Report to the Hearing Committee on a notified resource consent application

Activity: To construct, operate and maintain a 4.4km shared path (cycleway and pedestrian access) along the seaward edge of Marine Drive.

File Reference: RM190124

Applicant: Hutt City Council Transport Department

Figure 1 Reefs at Point Howard/Sorrento Bay. The foreground area is proposed to be a formed carpark with revetment extending out and overlaying part of the reef outcrops (red-brown rock). The shared use path passes to the seaward side of the pohutukawa. It is important that the revetment rock is

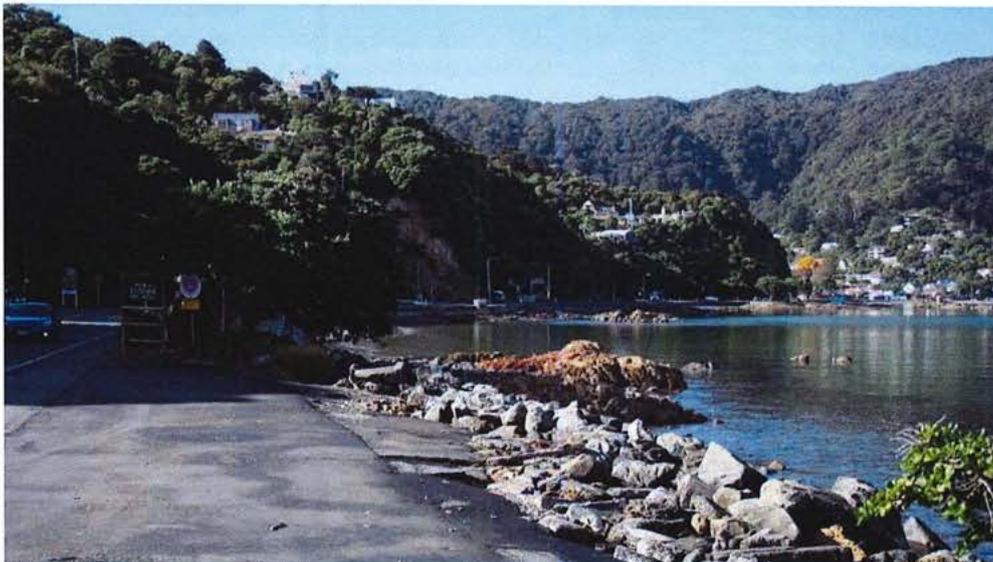
It is important that the rock used in the new revetment walls has a compatibility with the form, texture and colour of the existing bedrock seen in the area. The various bedrock reefs and outcrops are a distinctive feature of this part of the coast, helping to define each bay and the proposal will be seen very close to these outcrops in places. If imported rock material appears too 'different', it will stand out as foreign and draw the eye away from the natural features (Figure 1). In the DFR under 3.1.1 it states that *"The final selection of rock material for the revetment will be addressed by the contractor"*. While this may be adequate, it is preferable that a landscape architect, possibly aided by a geologist, be engaged to select any non-local rock material. It is important that the revetment works appear as 'low key' as possible as these structures extend some way out into the coastal environment and higher than the top of the shared use path. Any adverse effects on landscape and natural character which are currently agreed as being 'moderate' will be exacerbated with poor rock choice where these effects will become unacceptable.

compatible with the local rock colour as opposed to the contrasting grey rock used here in the rip rap. Photograph by J. Head May 2, 2019.

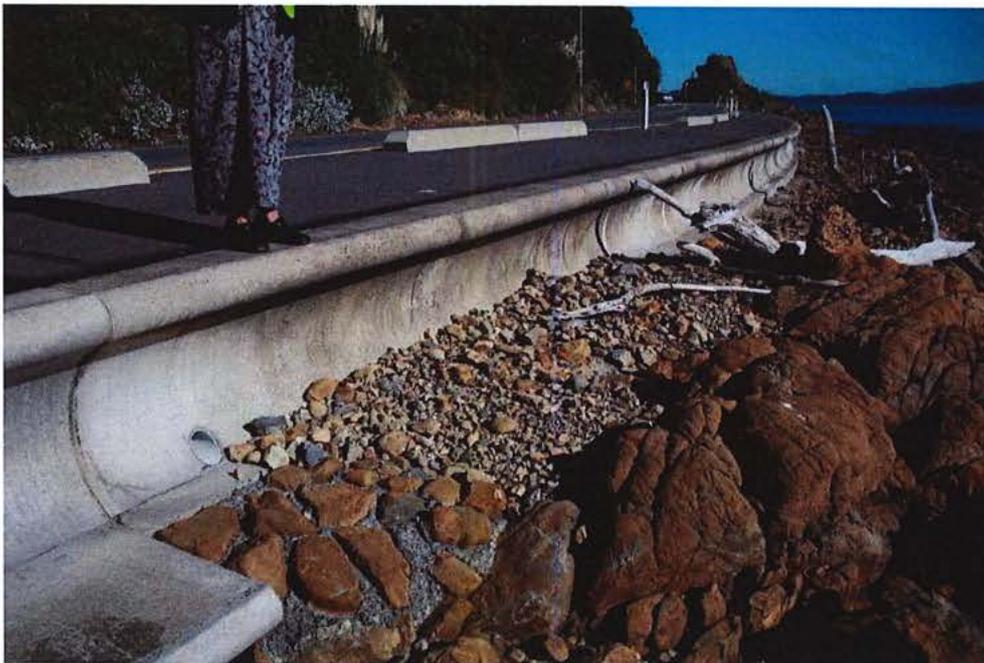
Where the curved sea wall 'treads' transition to single curved wall, it is recommended that the end of the tread is set into a large rock or series of rocks – possibly, in turn, set in a concrete haunching. This way the squared off end of the tread would not be visible with its contrived non-natural pattern dominating the surrounding natural rock patterns (Figure 3).

Figure 3 Unnatural transition from sea wall to rocky beach (to be avoided). The squared off end of the tread dominates the rock. It would have improved this transition if a large rock or a few large rocks were partially cast in to the end of the tread with minimal visible grouting (as opposed to here where the rocks set in the concrete matrix appears highly unnatural). Photograph by J. Head May 2, 2019.

these structures need to be adequately designed. It is noted here following a site visit that the existing concrete kerb separators (which the proposal is modelled on) in York Bay still have scope for improvement (Figure 3).

It is recommended that a 1:1 site sample be made that can be agreed on by the design team and community as part of the LUDP, for replication on site.

Overview

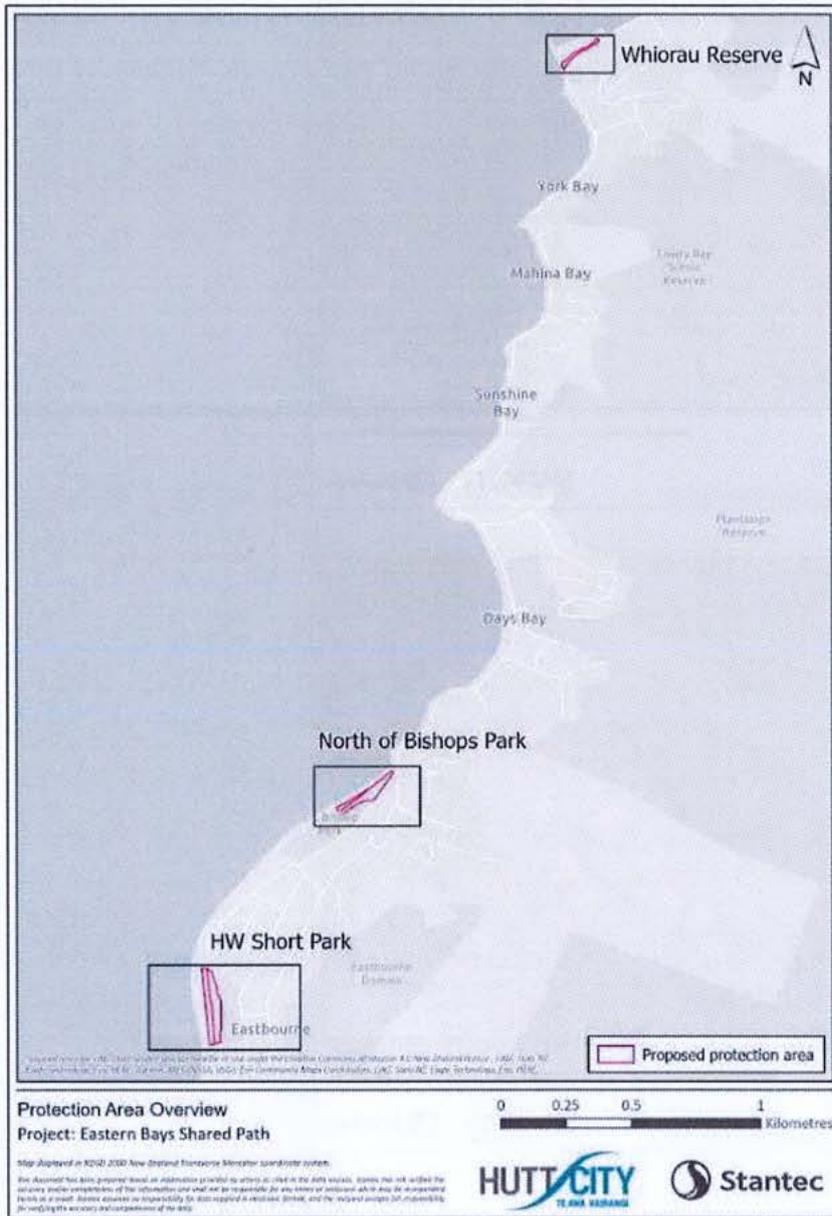
Commented [SW1]: Need to update to include Sorento Bay
